TITLE PAGE

Potesta Whole Home Remodel 43 Church St. Hudson, Ohio 44236

Elevation 14

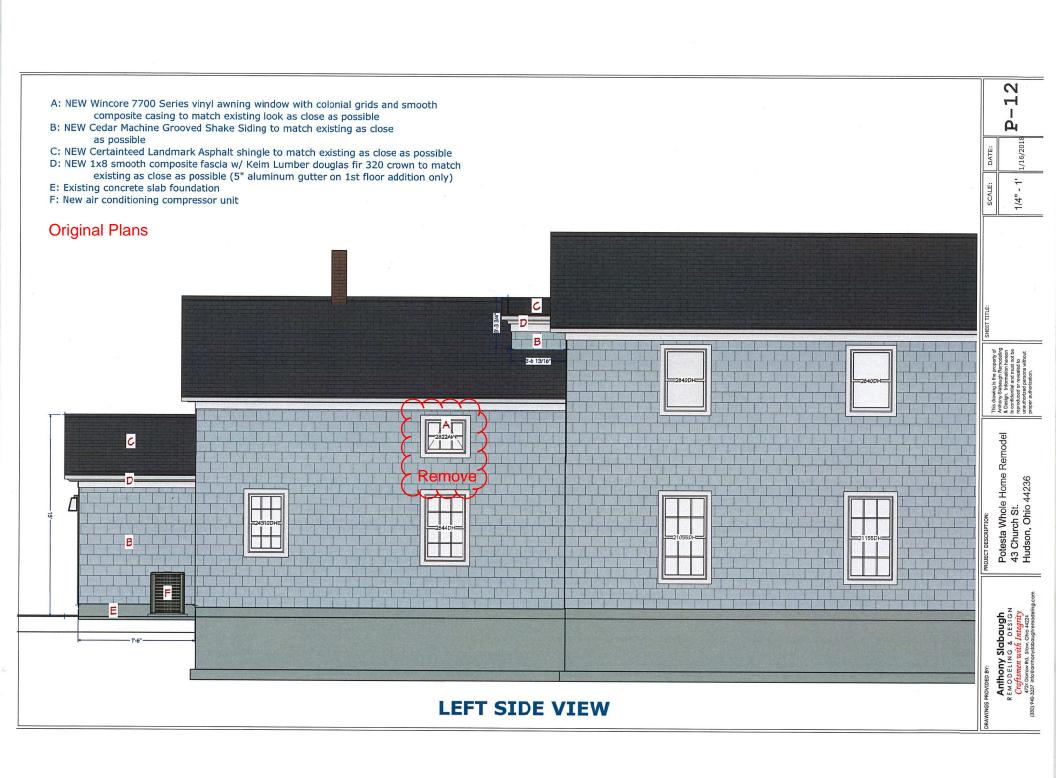
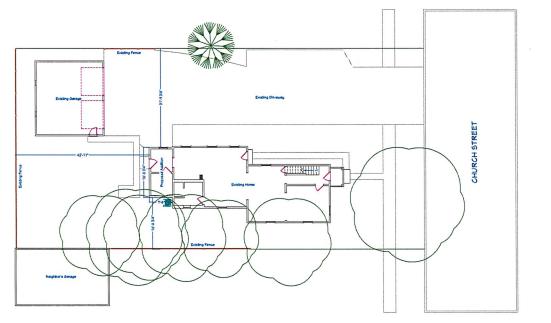
"We need to keep with a shed roof style for the purpose of the HVAC system as well as providing an egress worthy window on the 2nd floor. Otherwise, we would have to raise the roof height much higher so the HVAC can be routed properly (which would mean eliminating the window), or substantially reducing the slope of the gable (2/12, maybe 3/12 pitch, compared to the approximately 6/12 pitch the rest of their house has)."
